ADDENDUM NO. 2
to the
Iowa Department of Transportation
Proposal No. 17311
For
Hydraulic Cylinders
Revised Letting Date: September 16, 2016
~~**Letting Date: September 14, 2016**~~

Proposal 17311
Drawing 10
Stock Number 003-500080
Outer Ring Dimensions

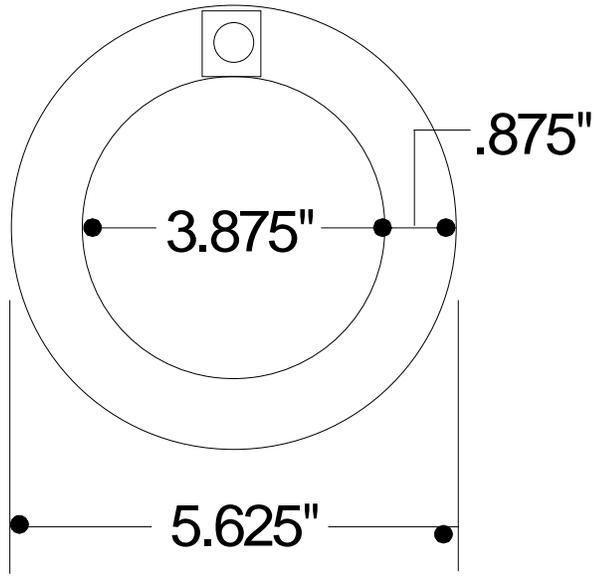
Question on 4.1 - Also the print is showing some sort of bracket on the case. The print I have did not come thru very well and we cannot tell what it is other than it's ½ thick. Can we get a drawing or sketch of this?

Answer - This is a ring and not a bracket that fits around the cylinder. See attachment for dimensions. This cylinder fits inside another housing on a newer ice blade and the ring helps center it (see picture attachment).
